RESOURCE CONSERVATION AND RECOVERY ACT
TEN-YEAR RENEWAL APPLICATION
FOR THE
WASTE ISOLATION PILOT PLANT
HAZARDOUS WASTE FACILITY PERMIT

Prepared by the
U.S. Department of Energy, Carlsbad Field Office
and
Nuclear Waste Partnership LLC

March 2020

Summary of Proposed Changes

Figure A1-25
CNS 10-160B Drum Carriage

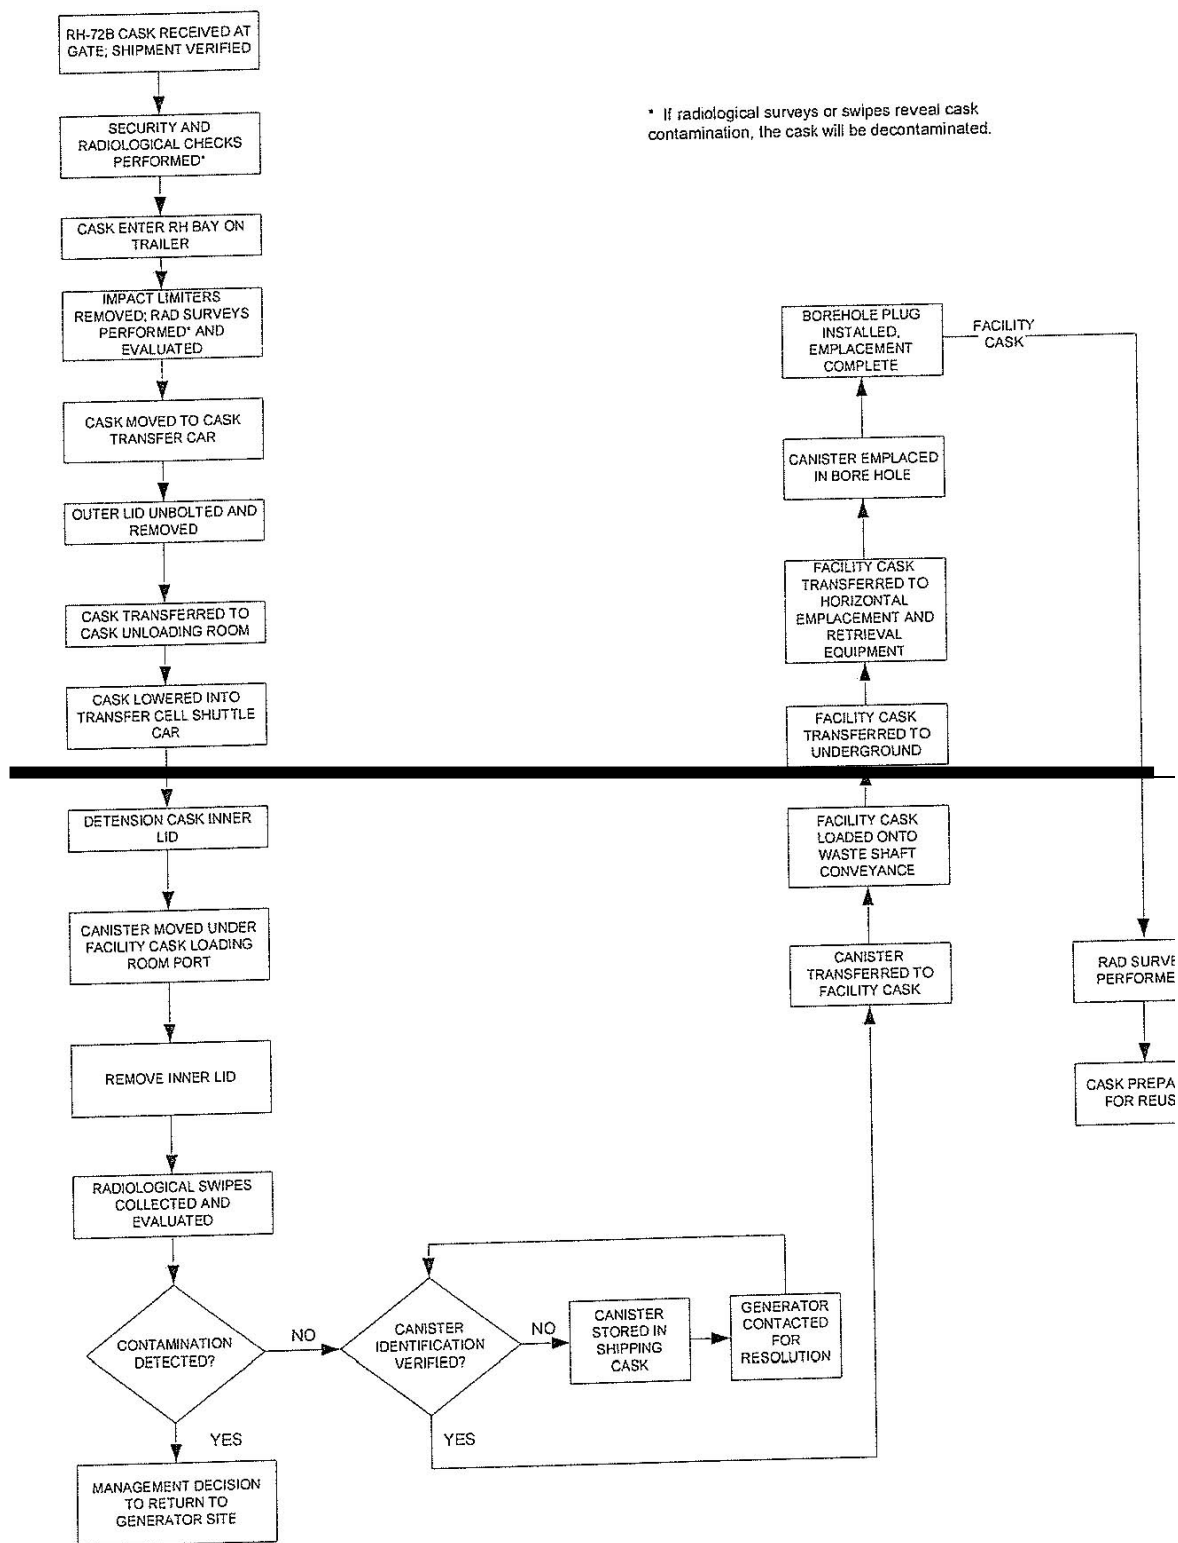
Permit Figure A1-25 CNS 10-160B Drum Carriage	Moved to Attachment M, Figure M-31.	Streamline the Renewal Application and ensure its accuracy and readability.
Permit Figure A1-26 Surface and Underground RH Transuranic Mixed	Moved to Attachment M, Figure M-40.	Streamline the Renewal Application and ensure its accuracy and readability.

Figure A1-26
Surface and Underground RH Transuranic Mixed Waste Process Flow Diagram for
RH-TRU 72-B Shipping Cask

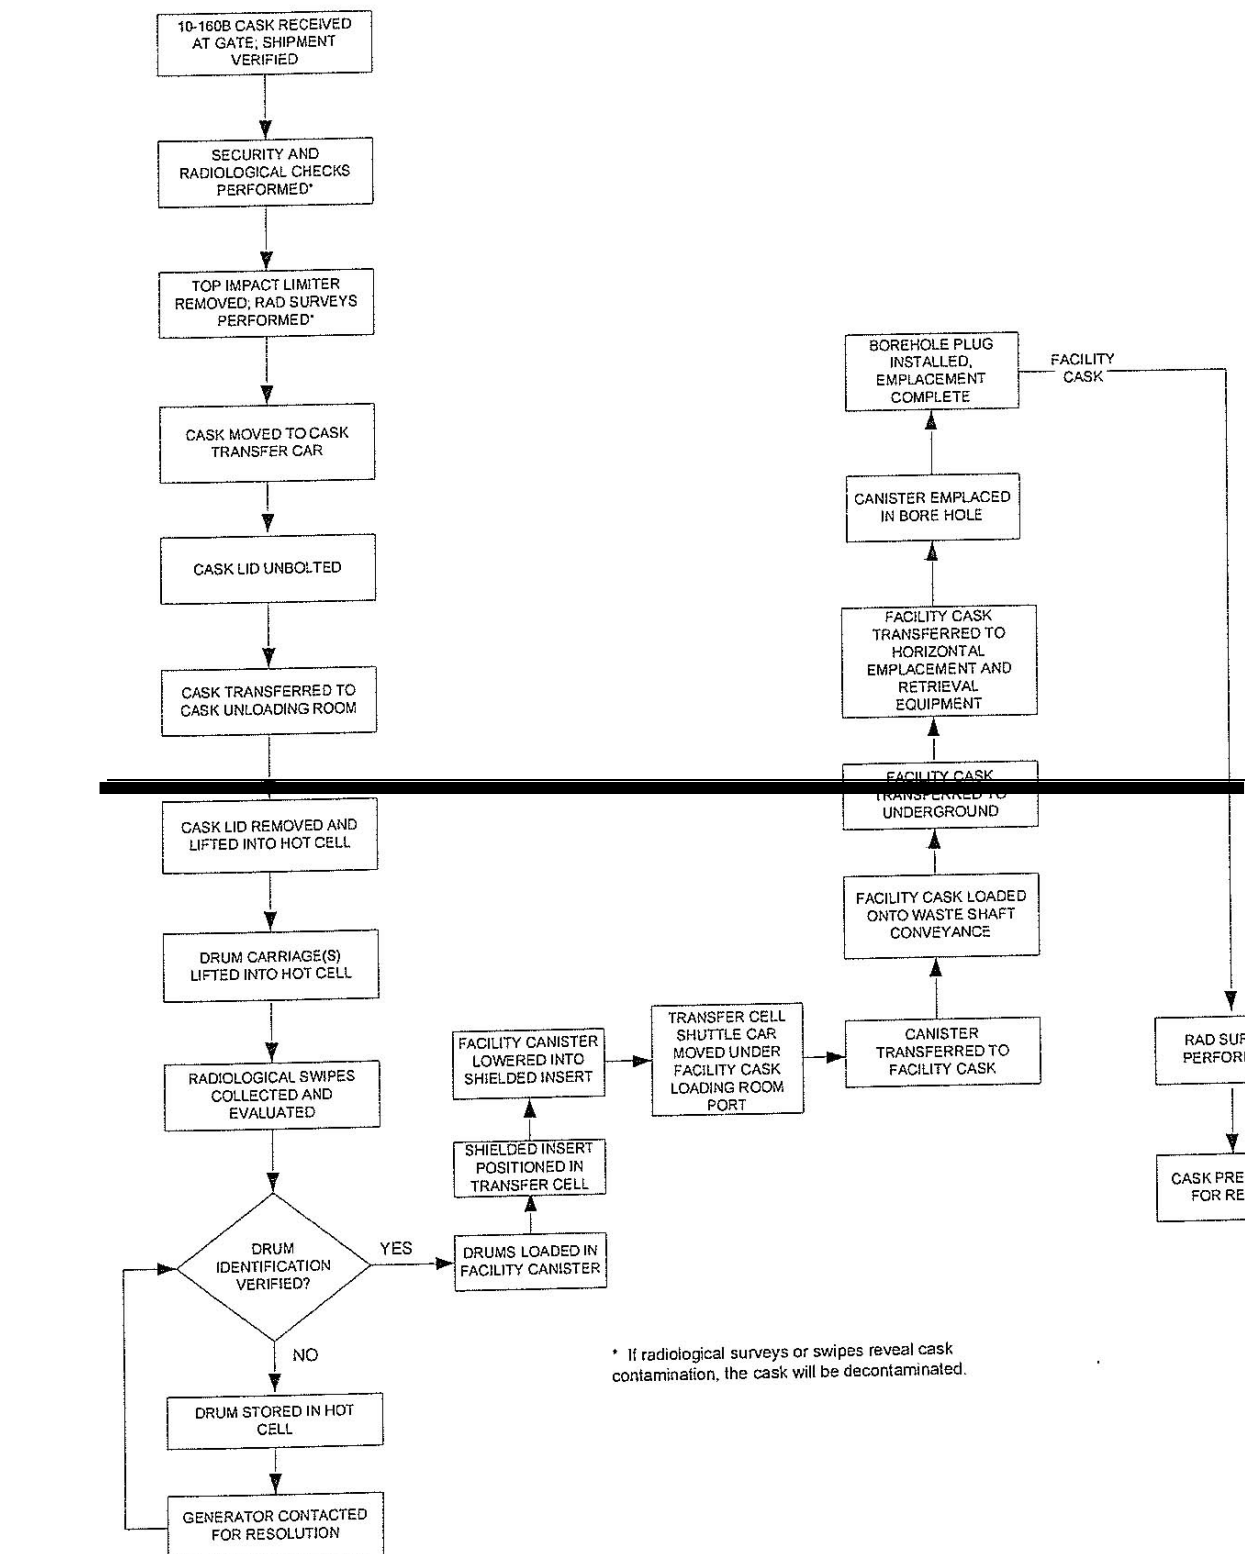
Renewal Application Section	Description of Change(s)	Discussion
Waste Process Flow Diagram for RH-TRU 72-B Shipping Cask		
Permit Figure A1-27 Surface and Underground RH Transuranic Mixed Waste Process Flow Diagram for CNS 10-160B Shipping Cask	Moved to Attachment M, Figure M-41.	Streamline the Renewal Application and ensure its accuracy and readability.
Permit Figure A1-28 Schematic of the RH Transuranic Mixed Waste Process for RH-TRU 72-B Shipping Cask	Figure removed.	Remove unnecessary detail that is not required by the New Mexico Hazardous Waste Regulations. The figure is not referenced in Permit text, is of poor quality, and does not add value to the descriptive text in Attachment A1; furthermore, there is not a comparable schematic in the Permit for the CH TRU mixed waste handling process.
Permit Figure A1-29 Schematic of the RH Transuranic Mixed Waste Process for CNS 10-160B Shipping Cask	Figure removed.	Remove unnecessary detail that is not required by the New Mexico Hazardous Waste Regulations. The figure is not referenced in Permit text, is of poor quality, and does not add value to the descriptive text in Attachment A1; furthermore, there is not a comparable schematic in the Permit for the CH TRU mixed waste handling process.

Figure A2-8
Typical RH and CH Transuranic Mixed Waste Container Disposal Configuration

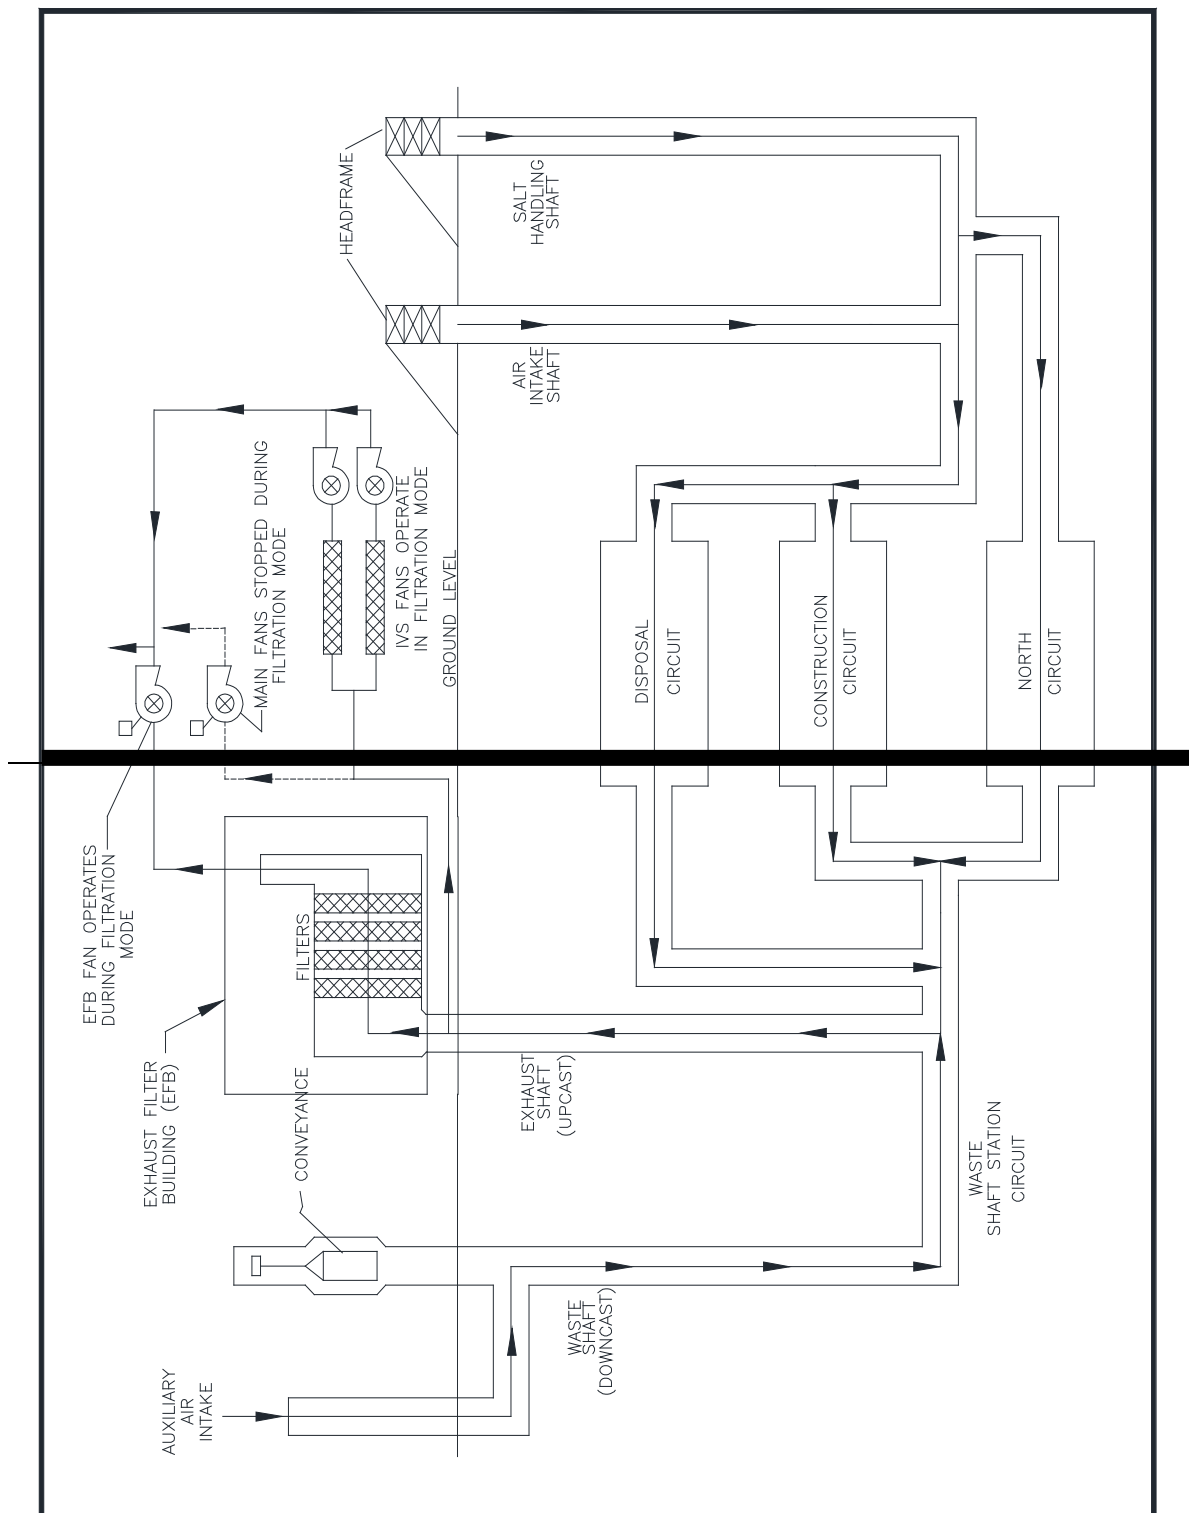
Permit Figure A2-7 Push-Pull Attachment to Forklift to Allow Handling of Waste Containers	Moved to Attachment M, Figure M-47.	Streamline the Renewal Application and ensure its accuracy and readability.
Permit Figure A2-8 Typical RH and CH Transuranic Mixed Waste Container	Moved to Attachment M, Figure M-48.	Streamline the Renewal Application and ensure its accuracy and readability.

Figure A2-9a-NFB
Underground Ventilation System Airflow (with Building 416)

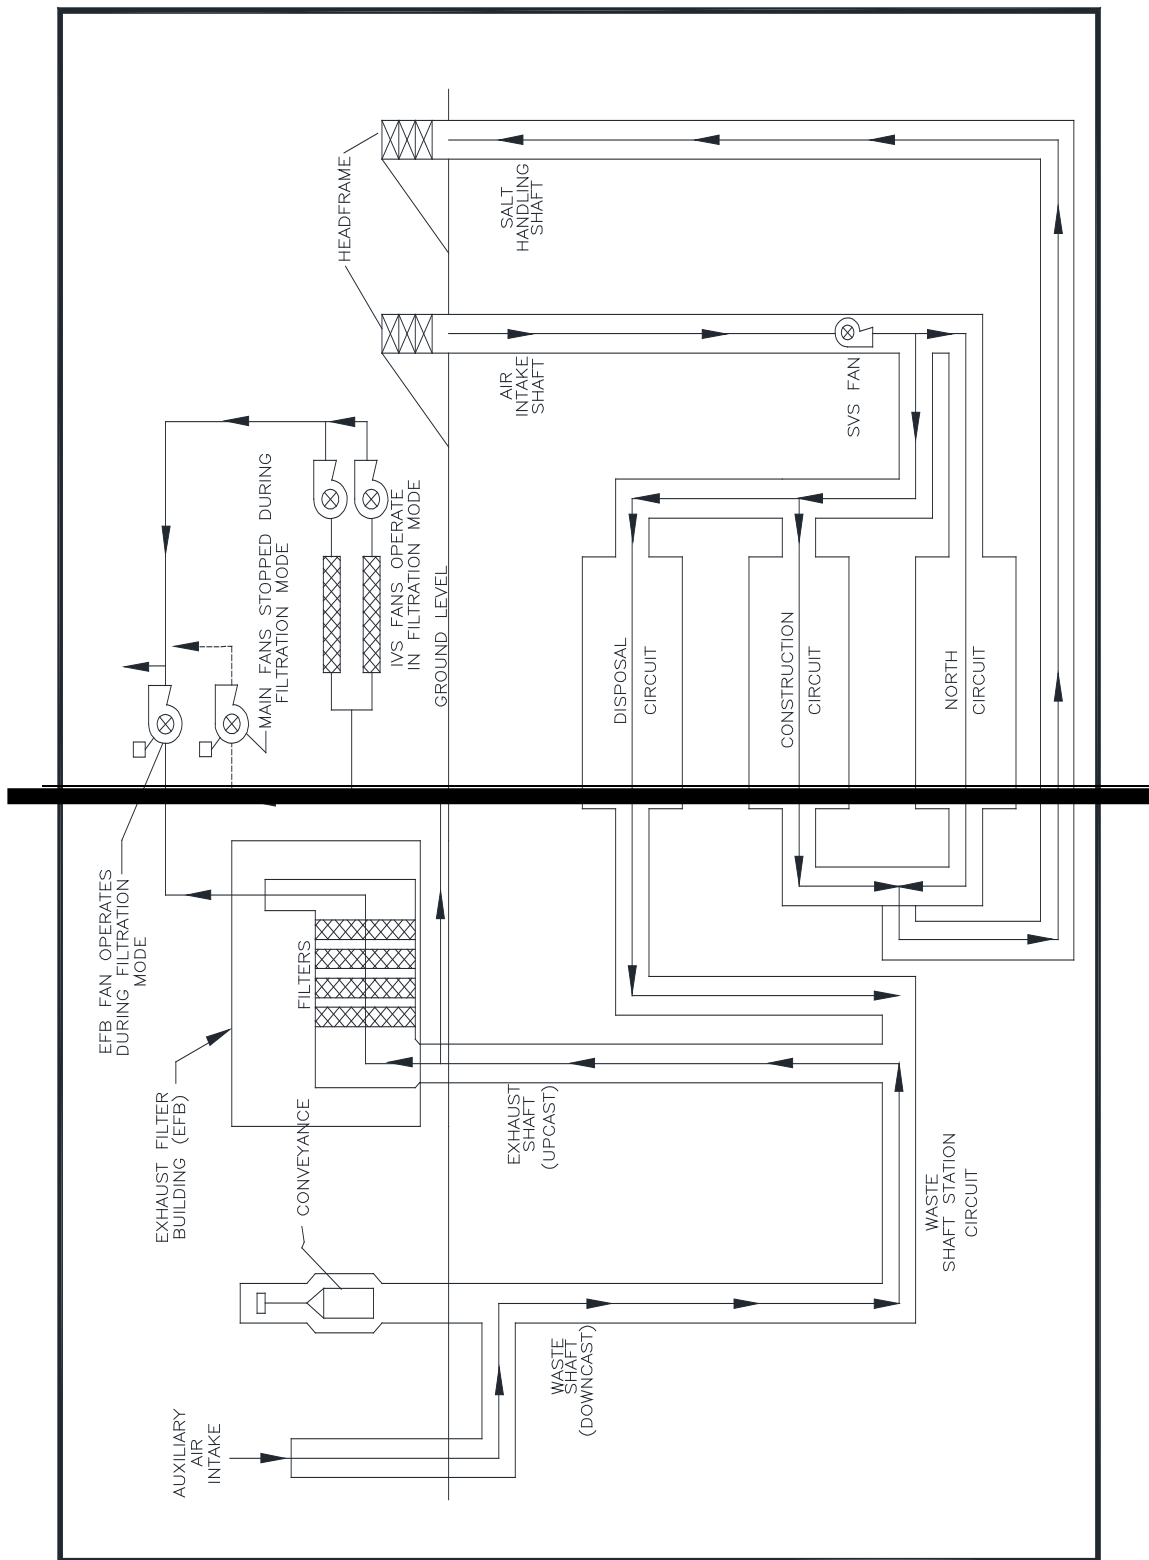
Renewal Application Section	Description of Change(s)	Discussion
Disposal Configuration		
Permit Figure A2-9a Underground Ventilation System Airflow	Moved to Attachment M, Figure M-49.	Streamline the Renewal Application and ensure its accuracy and readability.
Permit Figure A2-9a-NFB Underground Ventilation System Airflow (with Building 416)	Moved to Attachment M, Figure M-52.	Streamline the Renewal Application and ensure its accuracy and readability.
Permit Figure A2-9b Underground Ventilation System Airflow (with SVS)	Moved to Attachment M, Figure M-50.	Streamline the Renewal Application and ensure its accuracy and readability.
Permit Figure A2-11 Typical Room Barricade	Moved to Attachment M, Figure M-51.	Streamline the Renewal Application and ensure its accuracy and readability.
Permit Figure A2-11a Typical Bulkhead	Figure removed.	Streamline the Renewal Application by removing duplicative information. This figure is identical to one shown in Attachment G, Appendix G1-B. The reference in the text of Attachment A2 has been changed to Permit Attachment G, Figure G1-B.

Figure A2-12
WIPP Facility Surface and Underground CH Transuranic Mixed Waste Process Flow Diagram (Continued)

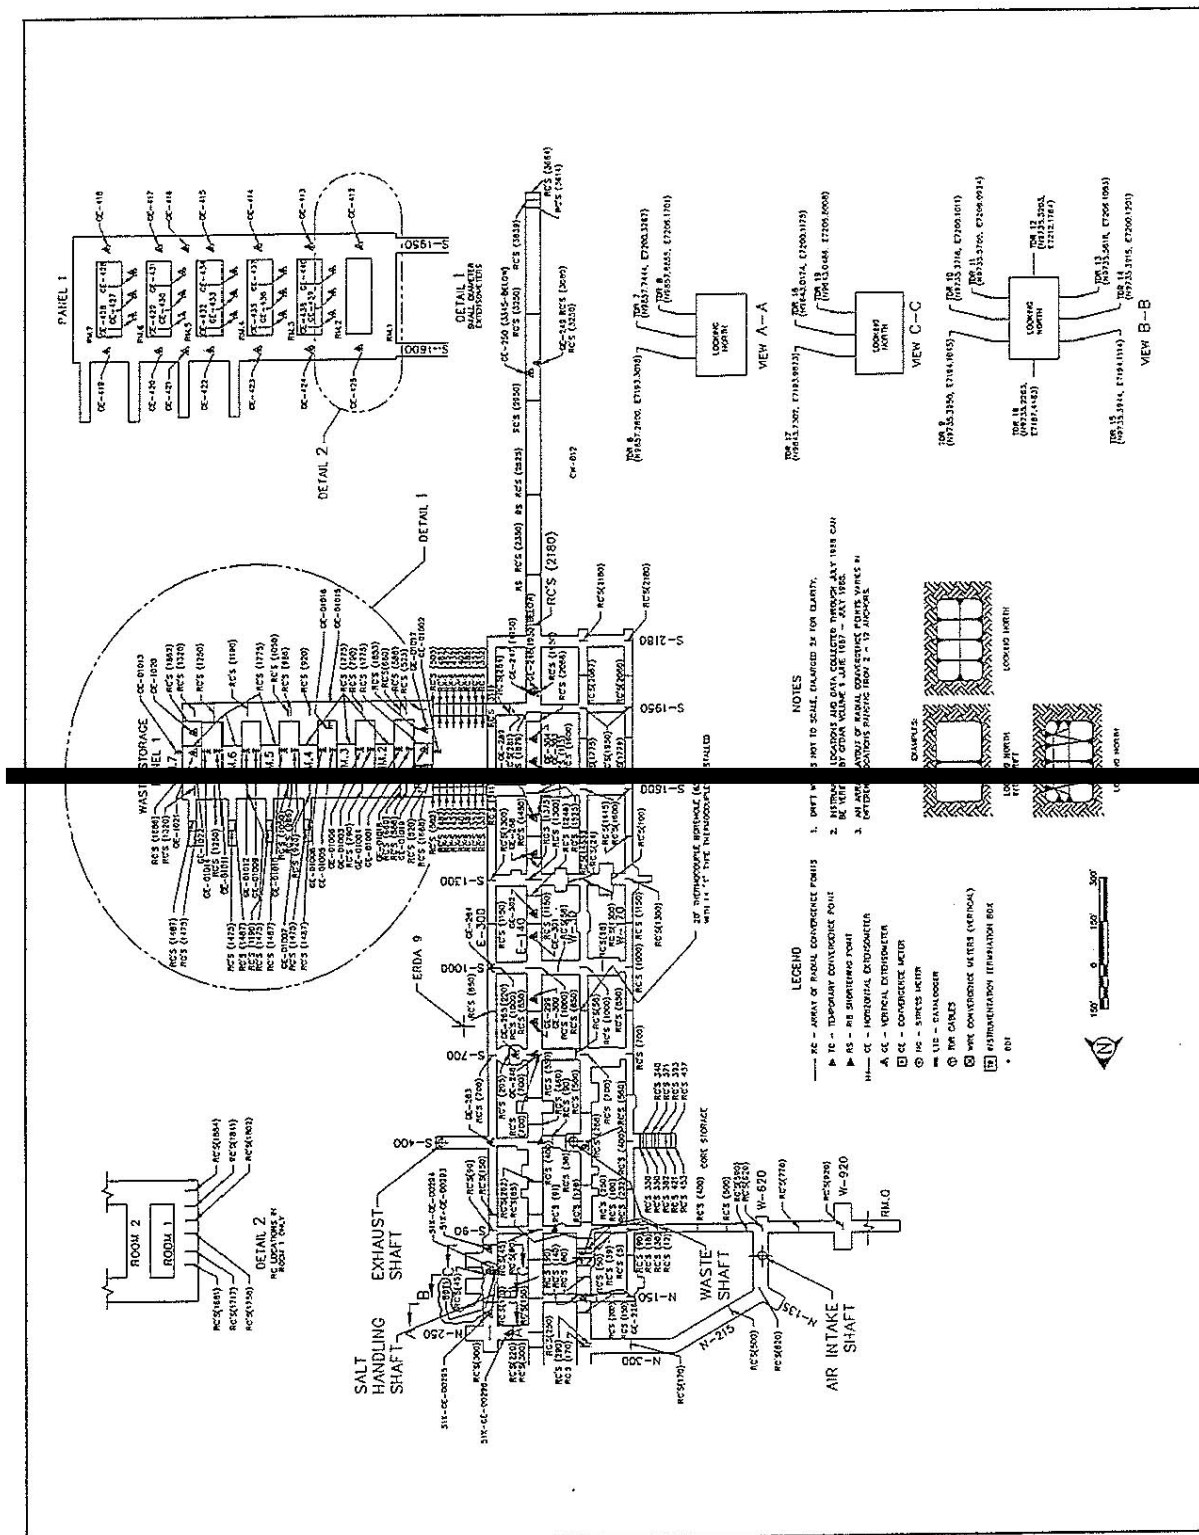
Permit Figure A2-12 WIPP Facility Surface and Underground CH Transuranic Mixed Waste Process Flow Diagram	Combined with Figure A1-13 and moved to Attachment M, Figures M-38 and M-39.	Streamline the Renewal Application and ensure its accuracy and readability.
Permit Figure A2-13 Layout and Instrumentation – As of 1/96	Figure removed.	Remove unnecessary information that does not support a Permit requirement and is not required by the New Mexico Hazardous Waste Regulations. This figure is of poor quality, and the reference to the figure in the text of Attachment A2 is vague and unclear; therefore, the figure does not effectively support the descriptive information.
Permit Figure A2-14 Facility Cask Transfer Car (Side View)	Combined with Figure A1-24 and moved to Attachment M, Figure M-34; changed title to “RH Facility Cask Transfer Car (Side View).”	Streamline the Renewal Application and ensure its accuracy and readability.
